Subject: [External] Date and time selected for review of Sycamore Canyon Mega-warehouse proposal review by Council

Sycamore Canyon Business Park Buildings 1 and 2 State Clearinghouse No. 2015081042

RE: Sycamore Canyon Business Park Buildings 1 and 2, Notice of Draft EIR
ATTN: Kyle Smith, AICP, Senior Planner

Figure 3 - Proposed Site Plan
Sycamore Canyon Business Park Buildings 1 and 2

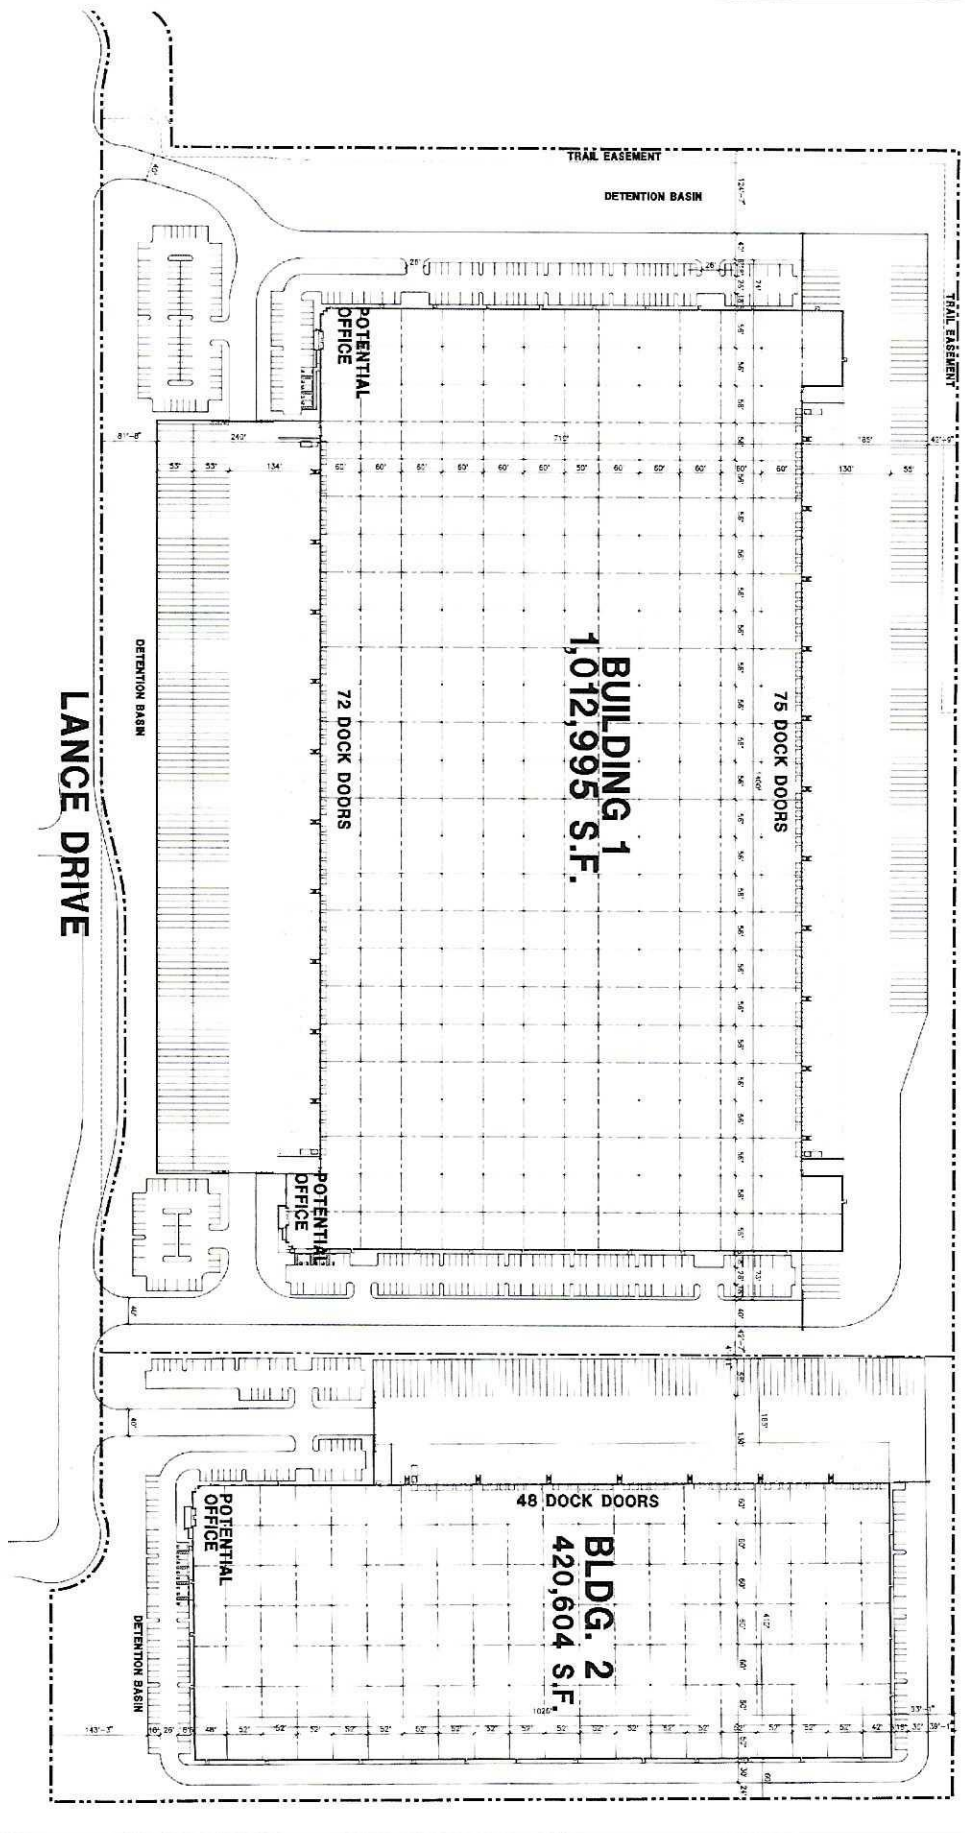
With the improving economy, development agencies are moving forward to build in the remaining open area of the Sycamore Canyon Business Park adjacent to our homes. Recently, an industrial warehouse development was approved by the City for the open space immediately behind the apartments and some of our community homes following some opposition of the residents in that area. This has emboldened other development companies to pursue further development. We just received notice for a proposed development in the southeast corner of the Business Park (adjacent to most of the homes in our community that border the Business Park). See the attached document for plans and maps.

This development is proposed to be two very large warehouses, one the size of the Big 5 warehouse that is already a nuisance due to noise. Of course the nearness of the proposed development would result in greater environmental impacts to the community relative even to the Big 5 mega warehouse.
